WEST SUSSEX COUNTY COUNCIL CONSULTATION

TO:	Horsham District Council FAO: Nicola Pettifer
FROM:	WSCC Highways - Public Rights of Way
DATE:	27 January 2026
LOCATION:	New Place Nurseries London Road Pulborough West Sussex RH20 1AT
SUBJECT:	DC/24/1676 Reserved Matters application pursuant to Outline Planning Consent DC/21/2321, as varied by application DC/24/1204. The Reserved Matters comprise details of 160 no dwellings, associated internal access roads, parking and landscaping for areas east of the right of way. Details of appearance, landscaping, layout and scale to be considered. Recons request via email from Donna Trethewey on 26/01/2026.
DATE OF SITE VISIT:	n/a
RELEVANT PUBLIC RIGHTS OF WAY NUMBER(S):	FP2330, BW2332, FP3500, FP2331, BW2328
RECOMMENDATION:	Objection
S106 CONTRIBUTION TOTAL:	n/a

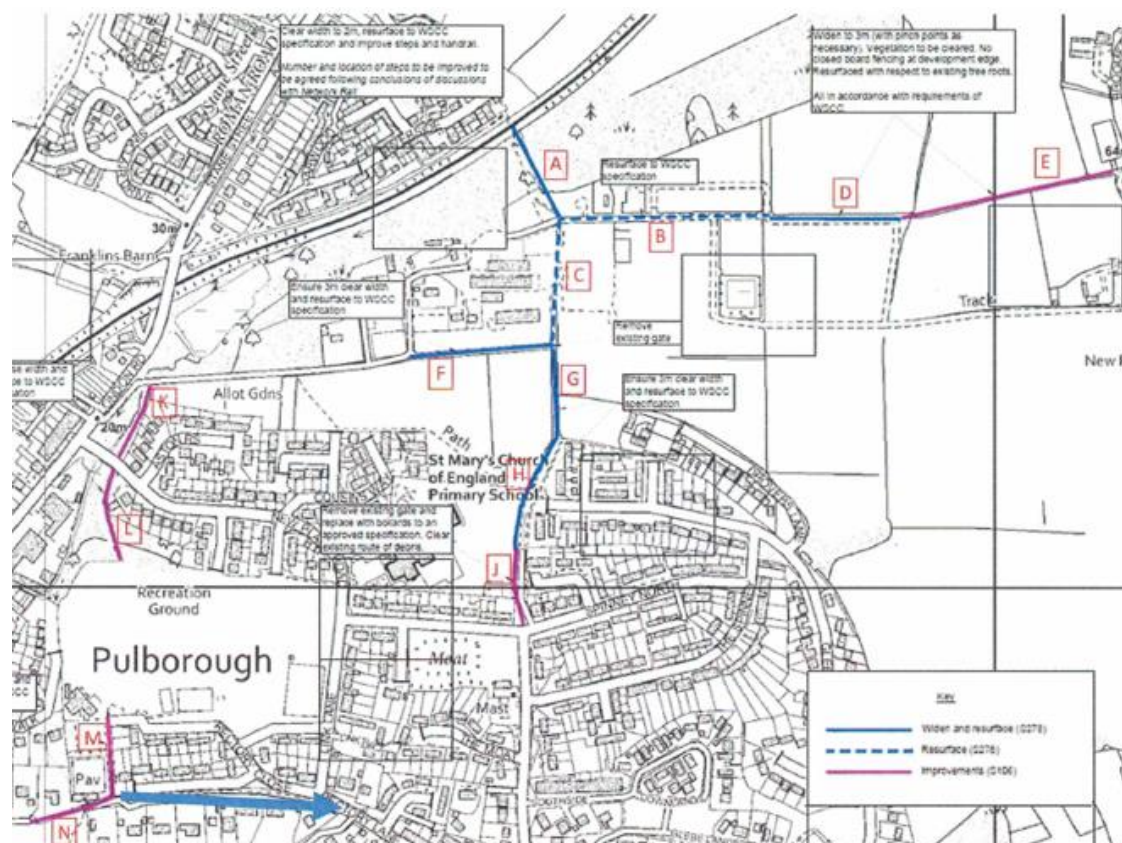
The Hard Surfacing Plan (excerpt below) shows affected Public Rights of Way (PRoW) as Buff Informal Paths. As stated in my response dated 19th February 2025, this may not be a surface that West Sussex County Council (WSCC) is set up to maintain. Please give specific surfacing details. Until then, I sustain my objection.

The east-west line shown to represent resurfaced BW2332 on the Hard Surfacing Plan (Section B below) appears to kink slightly in the middle which the current Definitive Line of the path does not. Please provide details on how much this deviation will be away from the Definitive Line. It may be necessary to apply for a diversion via Horsham District Council.

In addition, there is a buff path heading northwards from the kink. As this does not form part of the Public Right of Way network signage may be required to indicate the PRow path.

The Hard Surfacing Plan also appears to show the eastern section of Section B being narrower than that of the western section.
